Service Bulletin

Bulletin No.: 16-NA-197

Subject: Sunroof Glass and/or Sunroof Sunshade Inoperative

Date codes

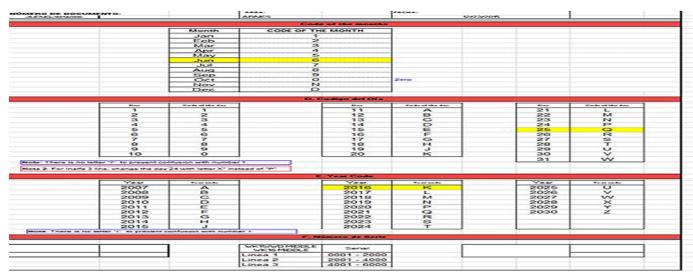
Follow the information listed below for inspecting the sunroof wiring harness label for date codes.

- If the harness code is prior to 6QK (June 25, 2016), then the harness is suspect and needs to be replaced following the procedure below.
- If the harness code is after 6QK, then the sunroof motors should be inspected. Refer to further diagnostics in SI.
